BRUCE H HAMILTON
Vice President
McGuire Nuclear Station

SUBJECT: Duke Energy Corporation
McGuire Nuclear Station, Units 1 and 2
Docket Nos. 50-369 and 50-370
NRC Generic Letter 2004-02, "Potential Impact of Debris Blockage
on Emergency Recirculation During Design Basis Accidents at
Pressurized-Water Reactors"

Response to Request for Additional Information

Figure 5-1
McGuire LBLOCA Expected Beginning and End of Life Sump pH Response

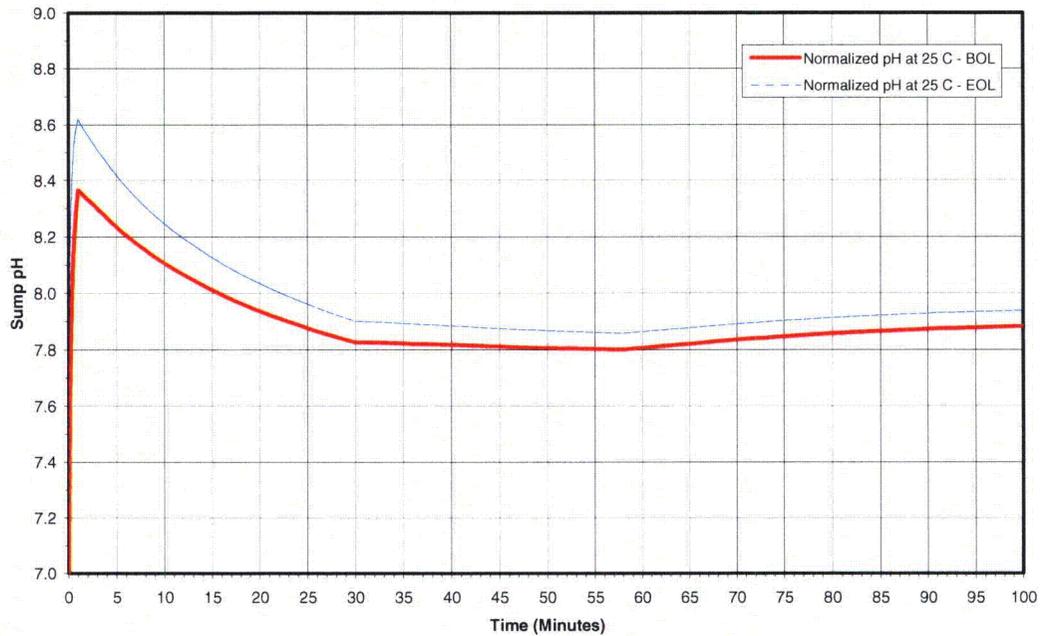
Provide the expected containment pool pH during the emergency core cooling system (ECCS) recirculation mission time following a LOCA at the beginning of the fuel cycle and at the end of the fuel cycle. Identify any key assumptions.

An analysis was performed to document how the ECCS sump pH was affected by both Beginning-of-Life (BOL) and End-of-Life (EOL) boron concentrations in the reactor coolant inventory. The EOL scenario, consisting of much lower concentrations of boron in the reactor coolant inventory, yields a higher sump pH profile than the same analysis for the BOL assessment. Figure 5-1 shows the time-dependent sump pH profile for both BOL and EOL cases, normalized to 25 °C.

that when the time range is expanded beyond 2 hours, there is an insignificant change in the ECCS sump pH.

Figure 11-1
Integrated Prototype Test Setup

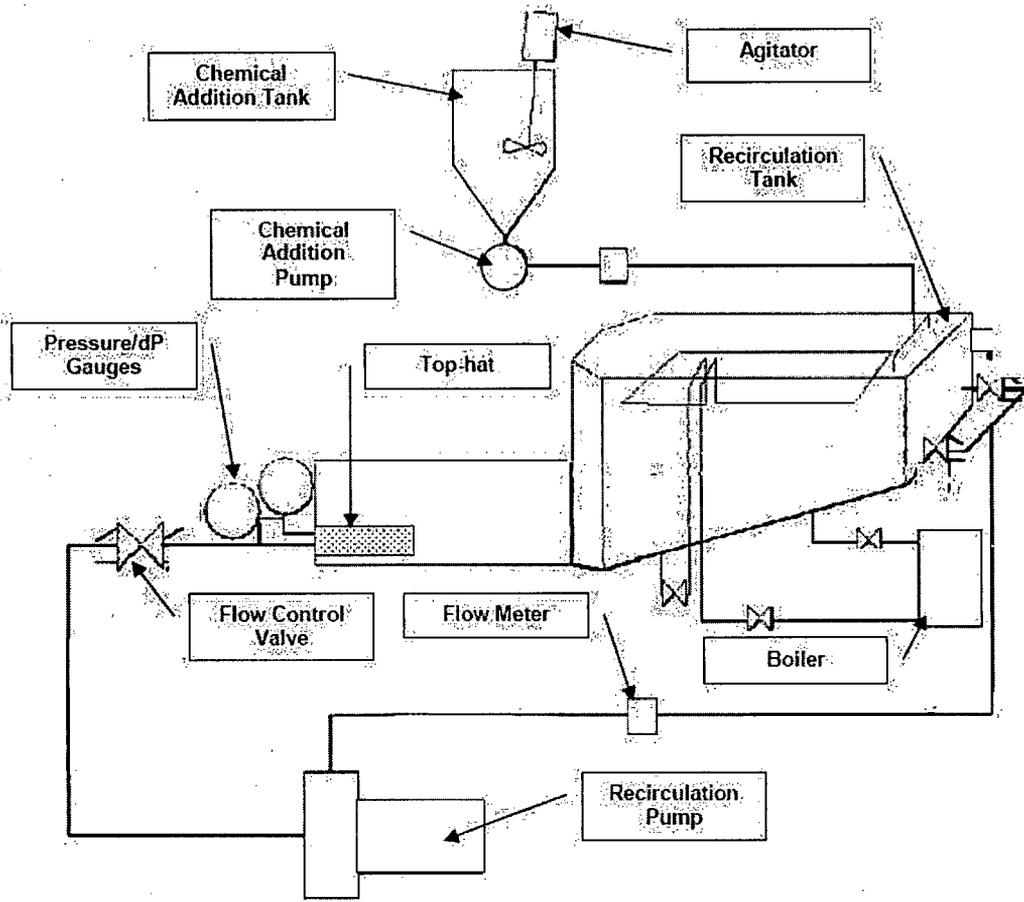
Provide a detailed description of any testing that has been or will be performed as part of a plant-specific chemical effects assessment. Identify the vendor, if applicable, that will be performing the testing. Identify the environment (e.g., borated water at pH 9, deionized water, tap water) and test temperature for any plant-specific head loss or transport tests. Discuss how any differences between these test environments and your plant containment pool conditions could affect the behavior of chemical surrogates. Discuss the criteria that will be used to demonstrate that chemical surrogates produced for testing (e.g., head loss, flume) behave in a similar manner physically and chemically as in the ICET environment and plant containment pool environment.

Duke's strategy to evaluate chemical effects on the modified ECCS sump strainer head loss employs an Integrated Prototype Test (IPT) designed to simulate the predicted comprehensive challenge to the McGuire and Catawba ECCS Strainer modules (top-hats) in the post-LOCA containment pool. The IPT, performed by Wyle Laboratories at their Huntsville, Alabama facility in fall 2007, combined the physical and chemical characteristics expected in the post-accident environment just prior to ECCS sump pool recirculation, and then challenged a prototype strainer top-hat in the recirculating pool for the full 30-day ECCS mission time while representative chemical effects were introduced.

A 36-inch long prototype top-hat module was utilized in the IPT test loop. This length is representative of the population of top-hat modules available on the McGuire Unit 1 and 2 modified strainers (24 inch, 30 inch, 36 inch and 45 inch) and dimensionally similar to the population of top-hat modules available on the Catawba Unit 1 and 2 modified strainers. All other top-hat parameters (e.g., base plate, mesh size, diameter) on the test prototype module are identical to those installed in the McGuire and Catawba ECCS sumps, including the bypass eliminator feature.

Figure 11-1 below shows the physical IPT rig setup.
